THIRD FLOOR

BEDROOM 3/
DRESSING ROOM
(EXISTING BOARDING)

1435 - P130

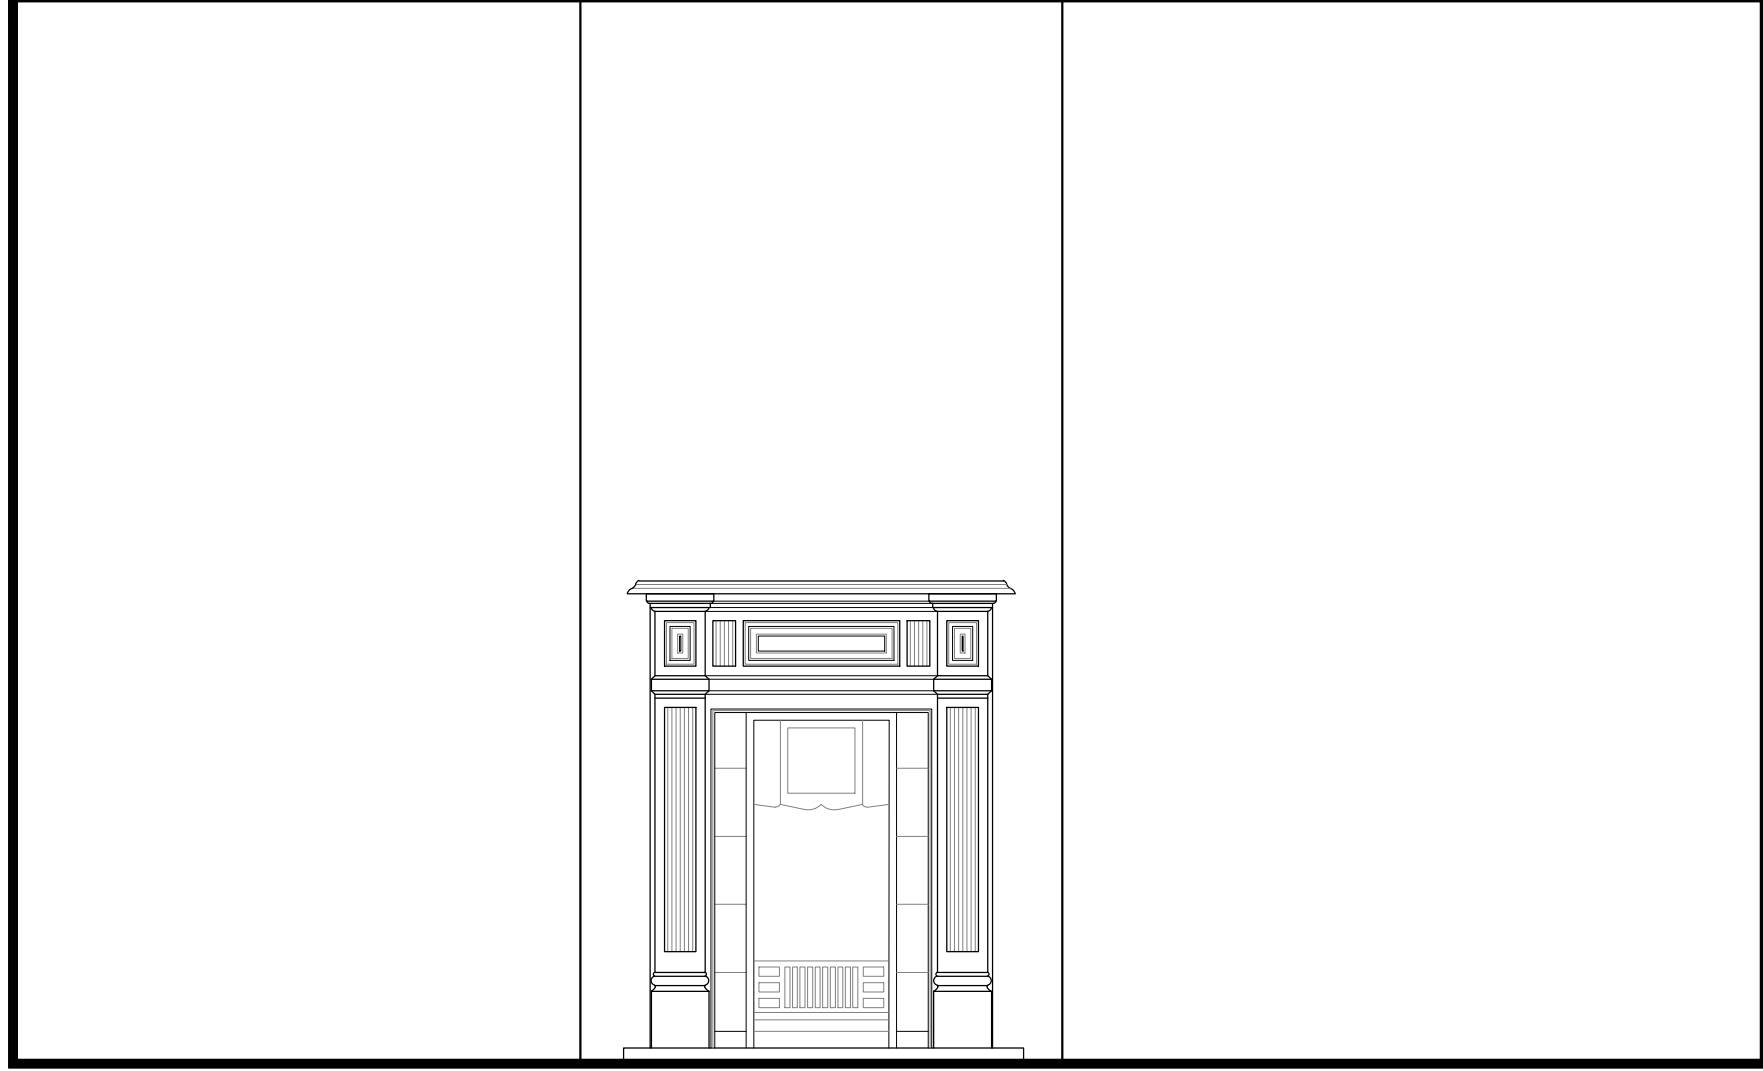
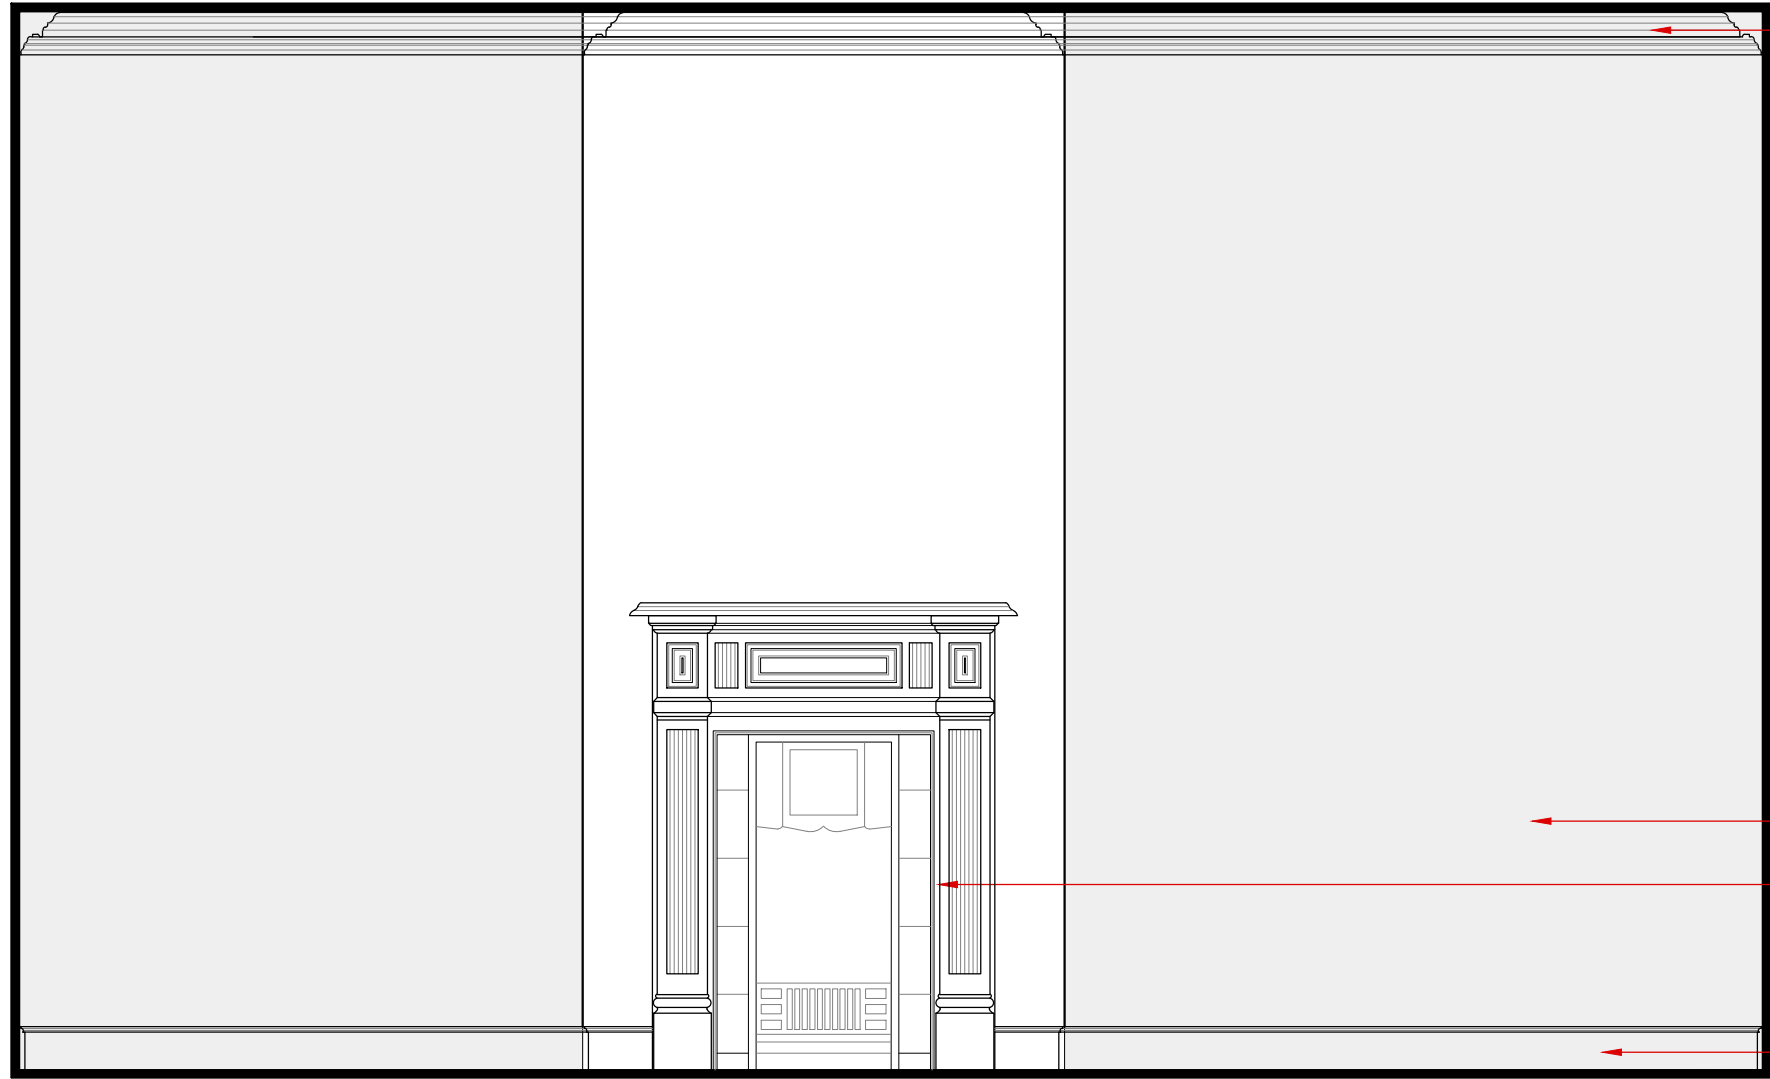
Rev	Date	Notes
A	23.06.15	Joinery added.

Proposed joinery.

Existing fireplace to be retained.

Existing skirting to be replaced to match Bedroom 3.

1435 - P133

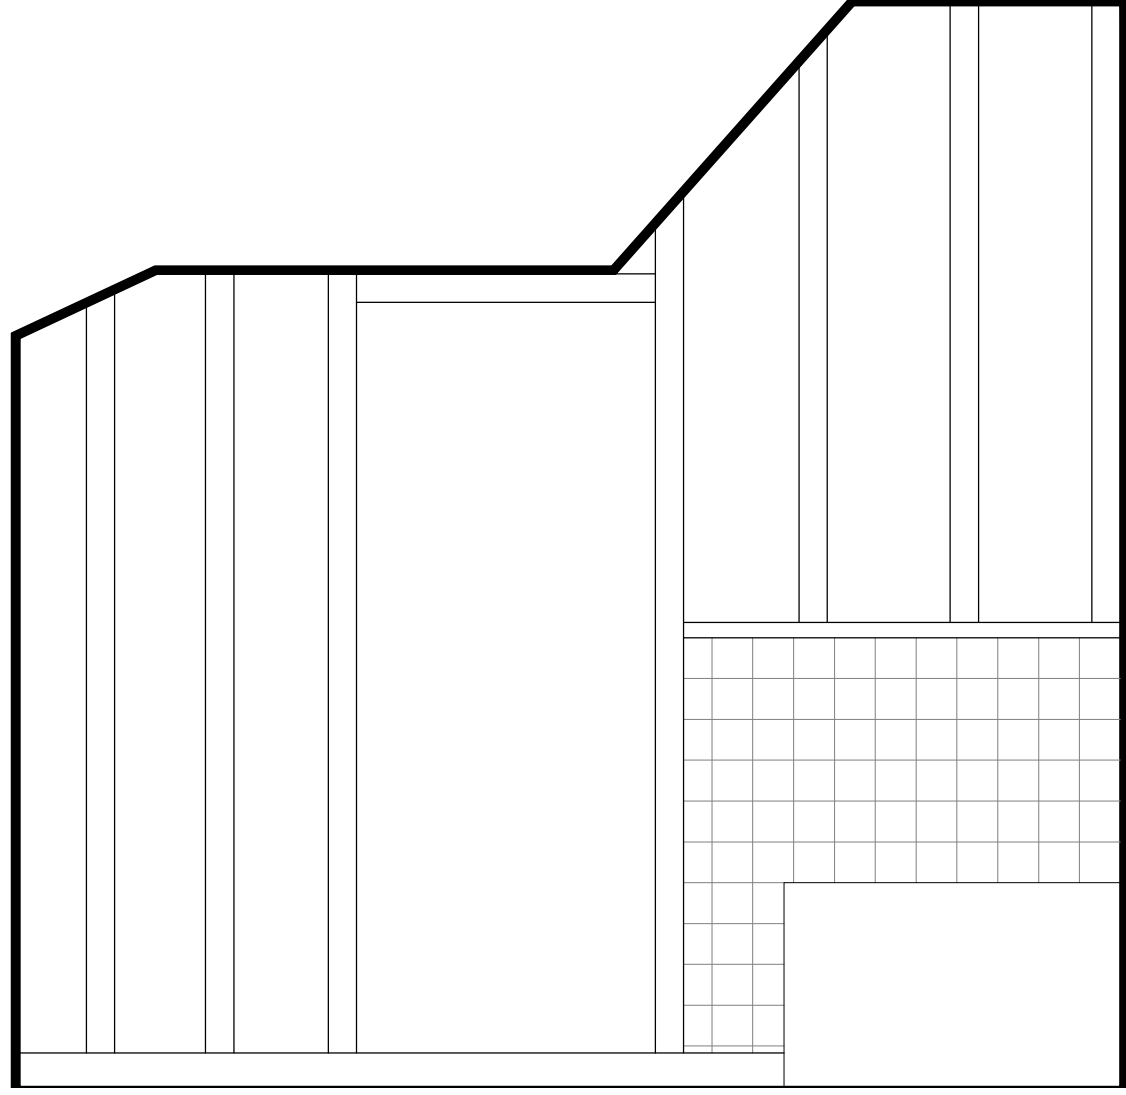
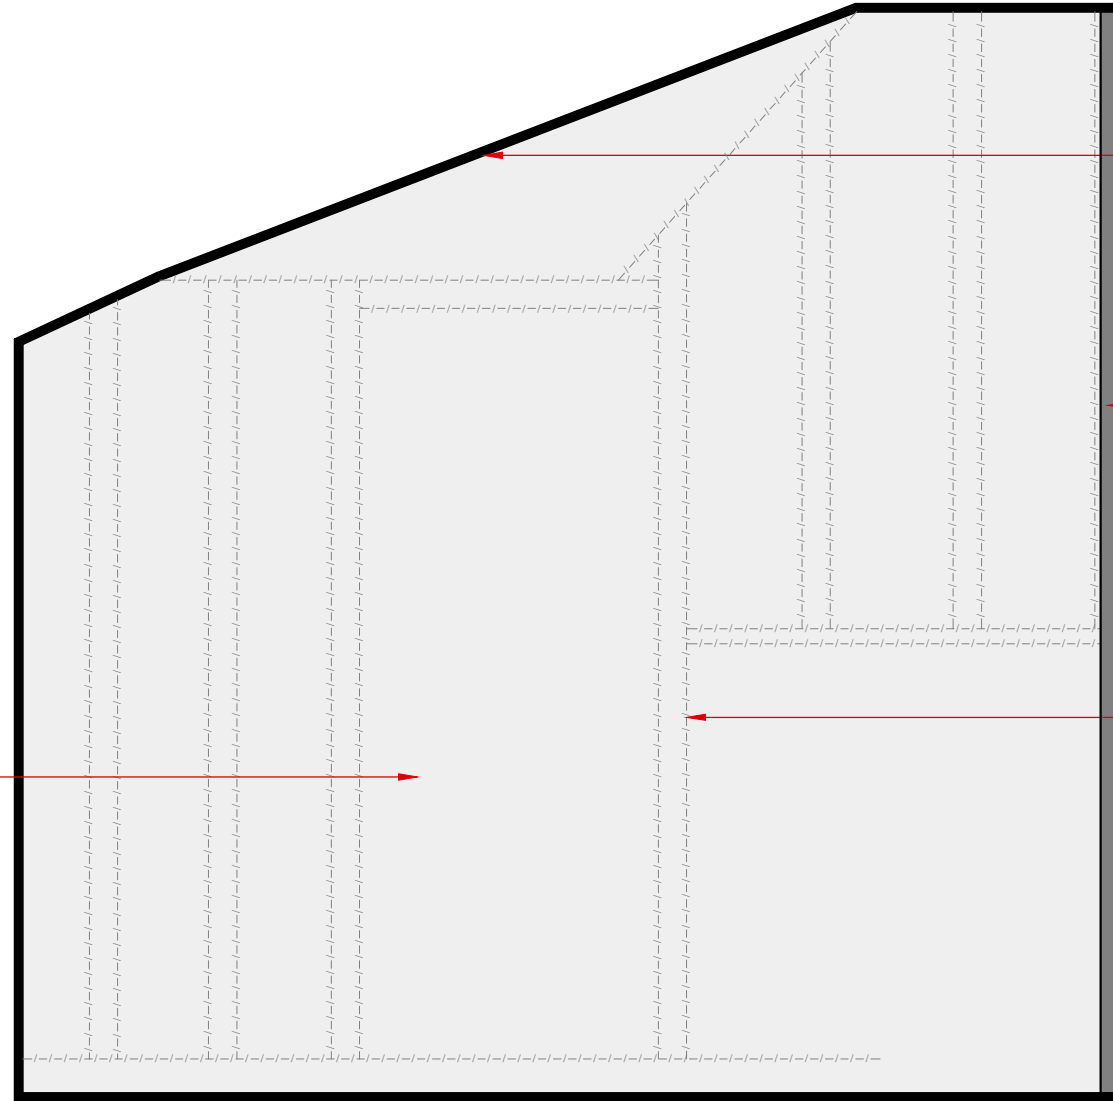
Rev	Date	Notes
A	14.05.15	Note to ceiling and wall revised following comments from council.
B	23.06.15	Room named changed and joinery added

Non original false ceiling removed and replaced to continue slope of ceiling in existing upper part of room. IE continue slope down from existing top down to eaves.

Existing non-original exposed stud work wall to be clad with plasterboard.

Existing false timber panelling to existing wall to be removed.

1435 - P134

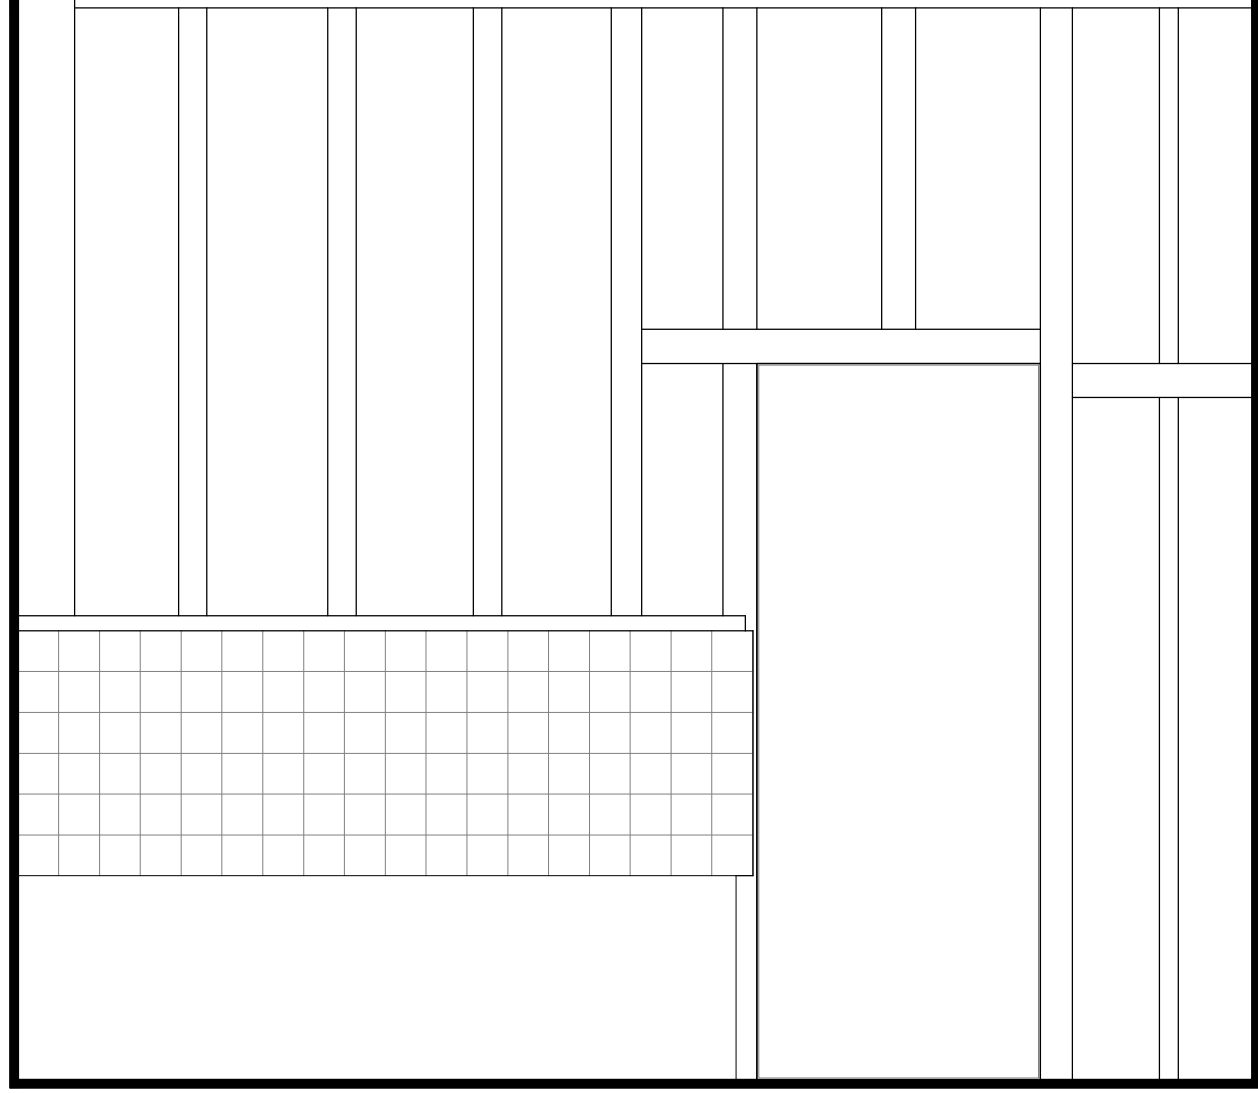
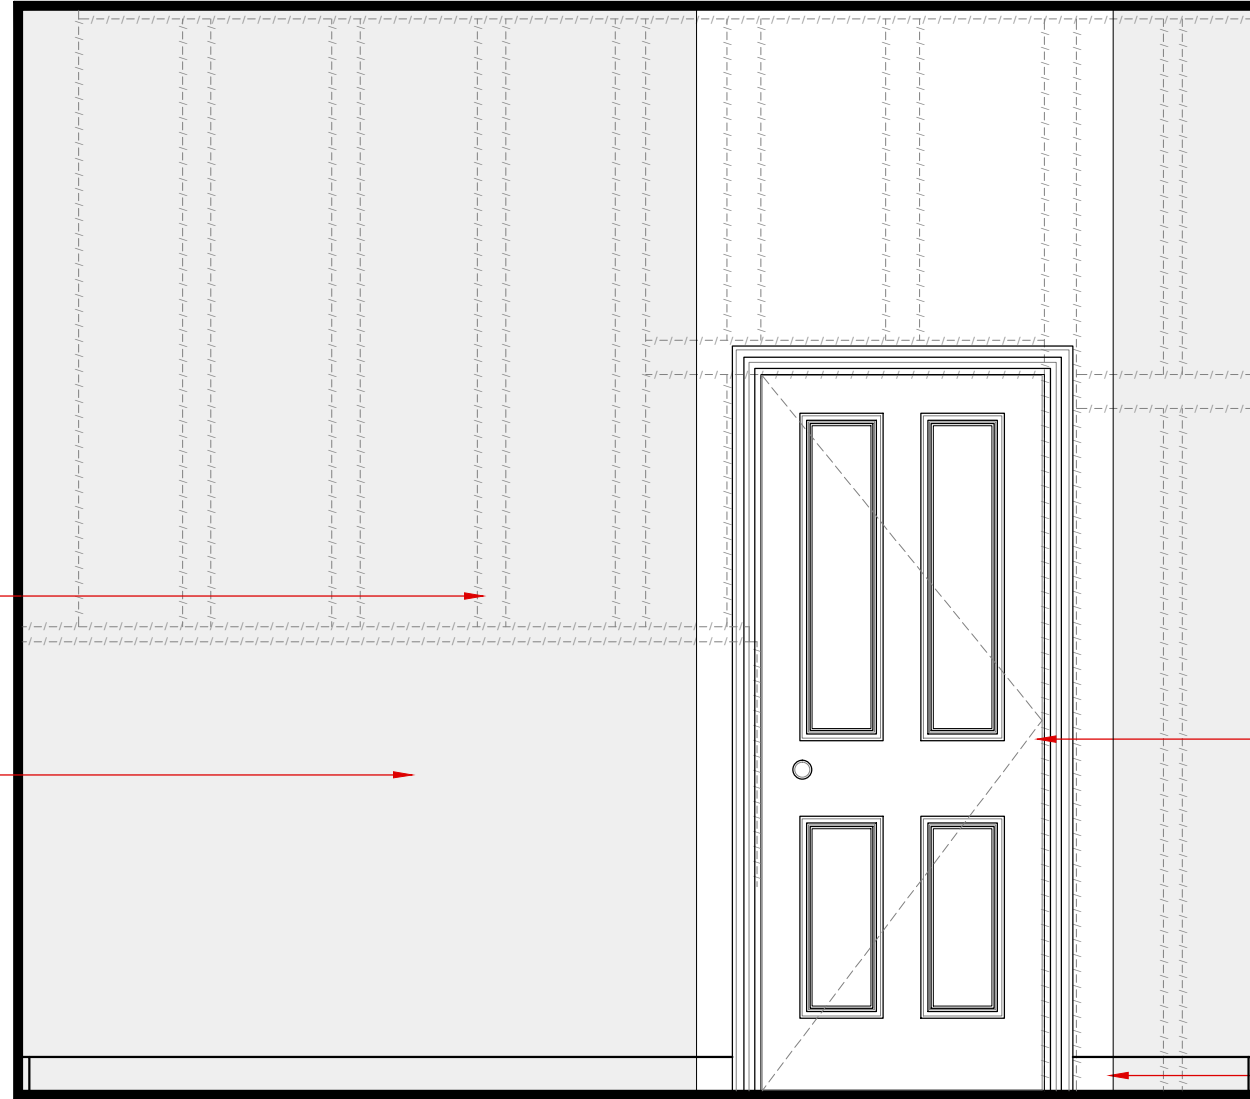
Rev	Date	Notes
A	14.05.15	Note to wall revised following comments from council.
B	23.06.15	Room named changed and joinery added

Existing non-original
exposed stud work wall
to be clad with
plasterboard.

Proposed door to match
existing.

Proposed skirting to
match existing.
